**Planning Application for
Minor Relaxation of Building Height Restriction for Residential Development
at No. 5 Lincoln Road,
Kowloon Tong, Kowloon
(New Kowloon Inland Lot No. 714)
(Planning Application No. A/K18/349)**

Response-to-Comments

Indication Plan A

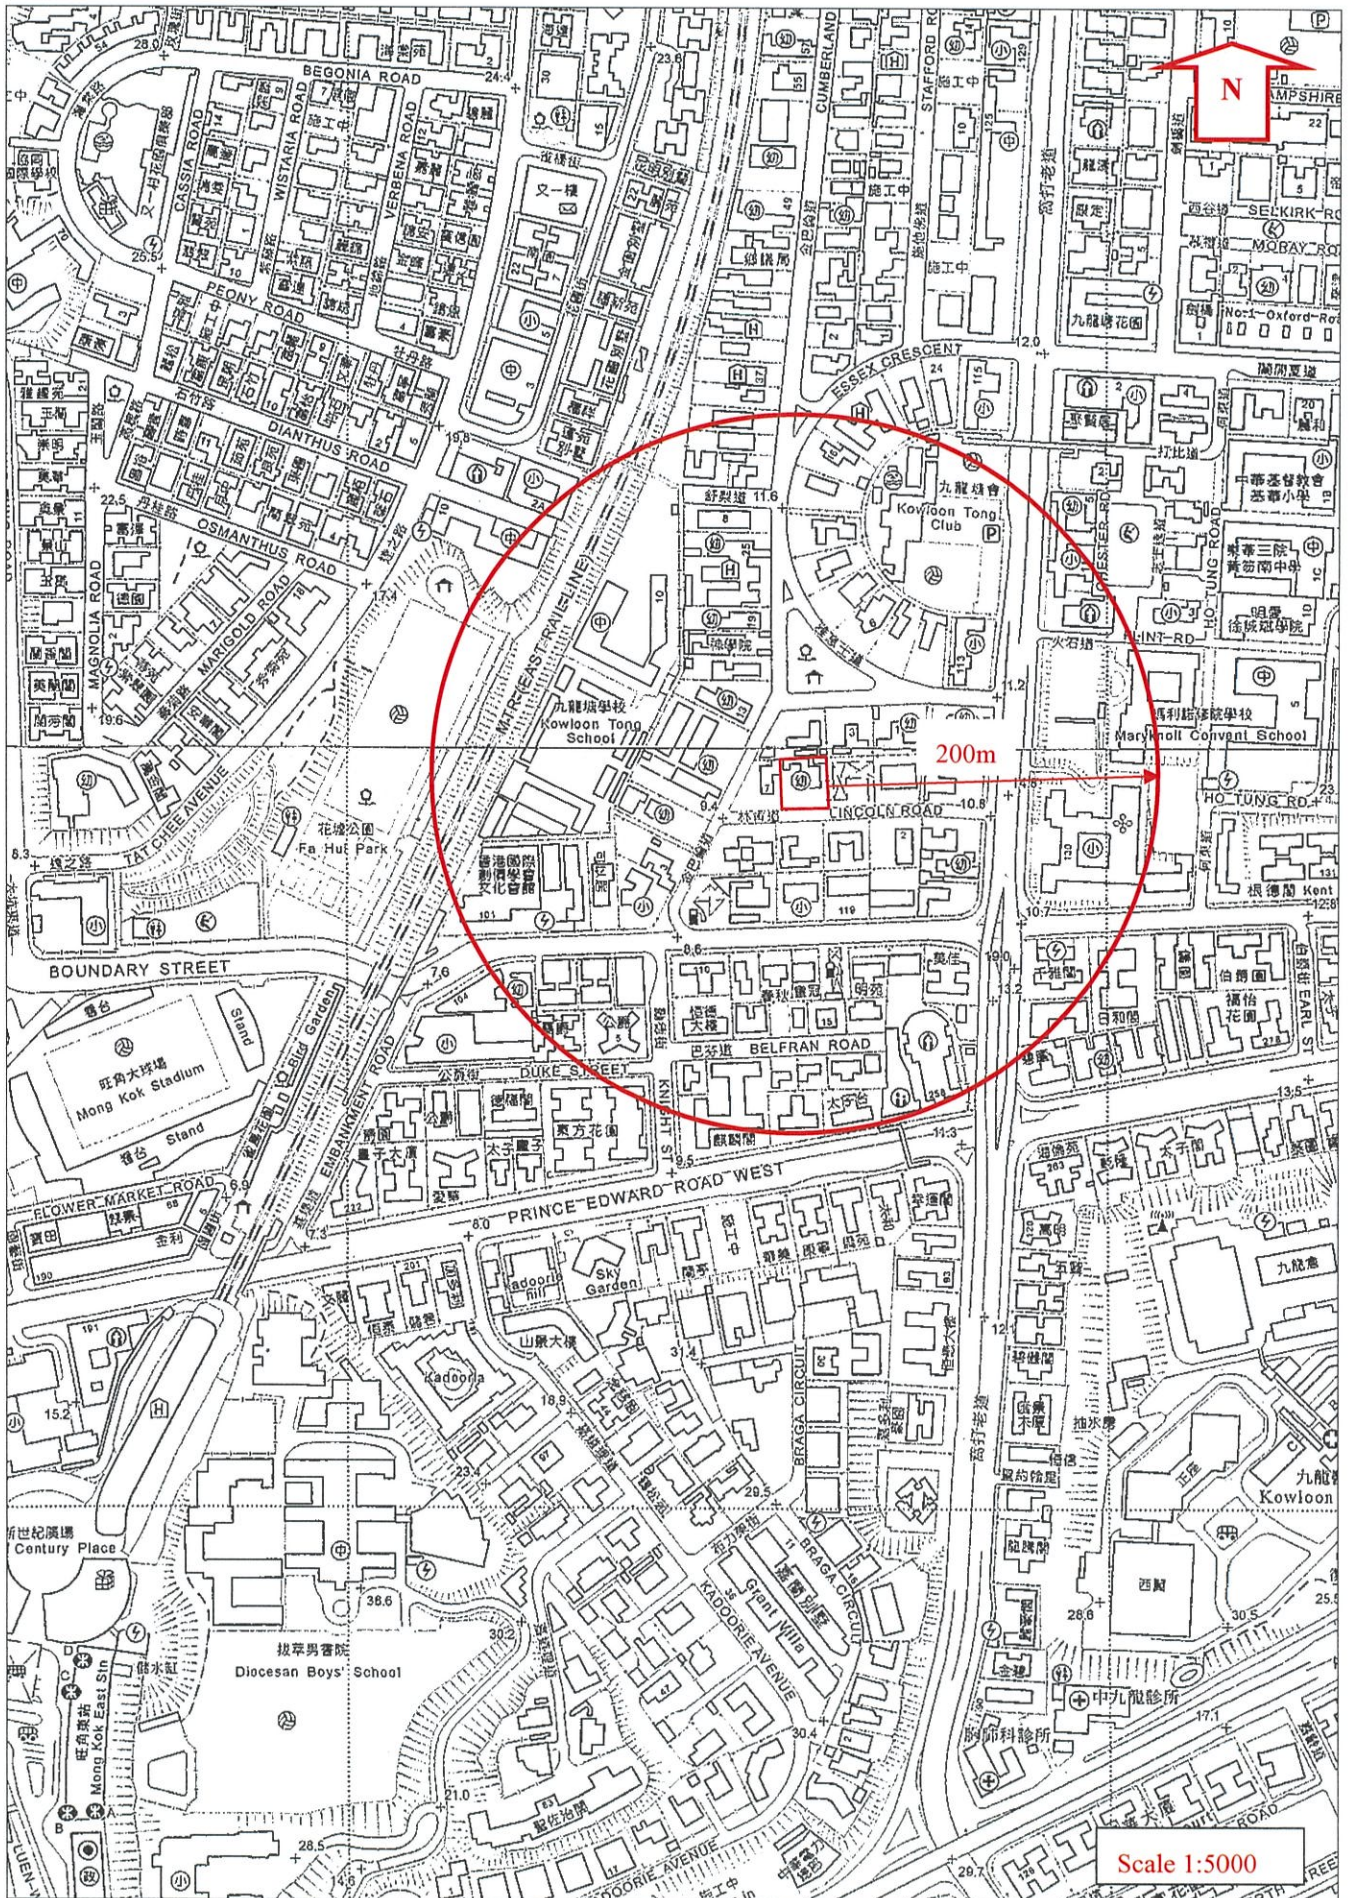
(i)	Please confirm whether the buffer distance requirements for vehicular and chimney emissions (e.g. any active industrial chimney within 200m) stipulated under the Hong Kong Planning Standards and Guidelines (HKPSG) (re. Table 3.1, Chapter 9, HKPSG) can be met.	<p>Please note the followings:</p> <ul style="list-style-type: none"> - there is no active industrial chimney within 200m from the site, as shown in the Indication Plan A; - the proposed house will be set back 6m from lot boundary in accordance with the non-building area (NBA) requirement for streetscape enhancement as stipulated under the Kowloon Tong Outline Development Plan (ODP). As shown in Indication Plan B, a total of 8m buffer distance (6m NBA and 2m pavement) for vehicular emissions from Lincoln Road is provided; and - planters will also be provided in the 6m setback NBA as greenery buffer. <p>Therefore, the buffer distance requirements for vehicular and chimney emissions stipulated under the Hong Kong Planning Standards and Guidelines (HKPSG) (re. Table 3.1, Chapter 9, HKPSG) can be met.</p>
